**Request for Additional Information No. 125 (1302, 1440), Revision 0**

**U. S. EPR Standard Design Certification**

**SRP Section: 09.03.04 - Chemical and Volume Control System (PWR) (Including  
Boron Recovery System)**

**Application Section: FSAR Section 9.3.4**

09.03.04-1, 09.03.04-12 → Figure 9.3.4-4—Reactor Boron and Water Makeup and Inventory Control System  
Sheet 1 of 2

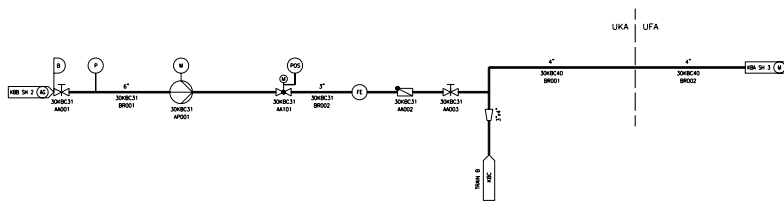
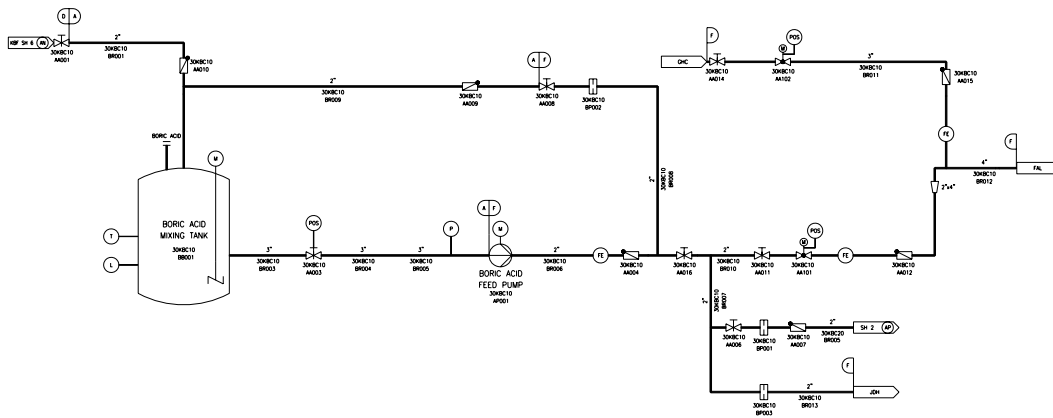
FSAR Tier 2 Section 9.3.4, page 9.3.4-47, under the heading reactor makeup and inventory control, states that the reactor boron and makeup water system is shown in Figure 9.3.4-4. However, the system name on Figure 9.3.4-4 is shown as the reactor makeup and inventory control system. These names appear to be used to refer to the same system. For example, Tier 2 Section 14.2, test #007 refers to the reactor boron and makeup water system, as does FSAR Tier 2 Section 6.8, extra borating system. To prevent possible confusion, a consistent name should be used throughout the FSAR.

The correct term for the system is the reactor boron and water makeup system. U.S. EPR FSAR, Tier 2, Section 9.3.4.2.1 and Figure 9.3.4-4—Reactor Makeup and Inventory Control System will be revised to indicate the above system name to agree with the Kraftwerks Kennzeichen System (KKS) coding for the KBC System. The title of the KBC system listed in U.S. EPR FSAR, Tier 2, Table 1.7-2—U.S. EPR System Designators and System Diagrams will also be changed to the terminology above.
